APPLICATION NO.	FILING DATE	FIRST NAMED INVENTOR	ATTORNEY DOCKET NO.	CONFIRMATION NO.
10/540,969	06/29/2005	Stephen Pasquarella	89200.000007	4313
23387 Stephen B. Sala	7590 06/04/200 ni, Esq.	EXAMINER		
Harter, Secrest	& Emery LLP	KOVAL, MELISSA J		
1600 Bausch & Lomb Place Rochester, NY 14604-2711			ART UNIT	PAPER NUMBER
			2862	
			MAIL DATE	DELIVERY MODE
			06/04/2008	PAPER

DETAILED ACTION

See Figure 1.

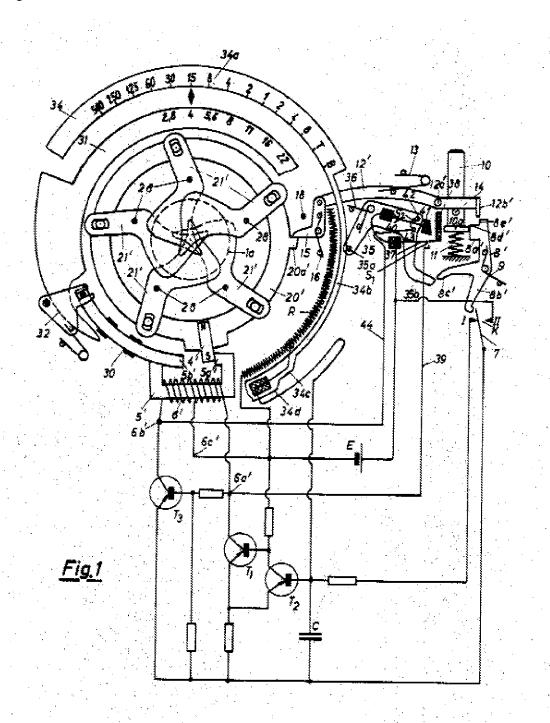
- (b) the invention was patented or described in a printed publication in this or a foreign country or in public use or on sale in this country, more than one year prior to the date of application for patent in the United States
- 4. Claims 15-17 are rejected under 35 U.S.C. 102(b) as being anticipated by Starp U.S. Patent 3,533,345.

5. Claim 15 sets forth: "A rotary photographic shutter or the like including a plurality of shutter blades (shutter blades 21') movable between an open and a closed position, a drive means including an actuator for moving the shutter blades between the open and closed positions (See driving ring 20' comprising permanent bar magnet 4' as well as fixed electromagnets 5' and 6'. Also see actuator lever 8') and a damping system operable to arrest the movement of the drive means at one of the open and closed positions (See spring 16, lug 20a and fixed pin 18).

See column 2, lines 65 through 75, and column 3, lines 1 through 50.
